Request for Class *II* Permissive Change(C2PC)

FCC ID: VG8EMB17GYY Data: 2020-11-10

Please be notified that we, the undersigned, Guangdong Midea Kitchen Appliances Manufacturing Co.,Ltd. declare that the reasons for this class II permissive change are as below:

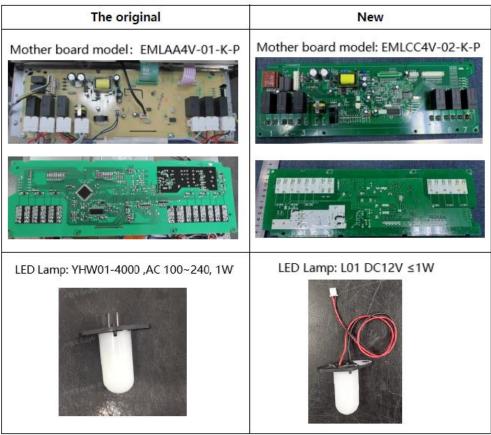
1. Changed Mother -board and LED Lamp as below.

- 1. The new mother board is the same input and output to the original except for PCB layout and some components differences.
- 2. The new LED lamp is DC 12V input, but the original is AC 100~240V.
- 3. Everything elses are the same as before.
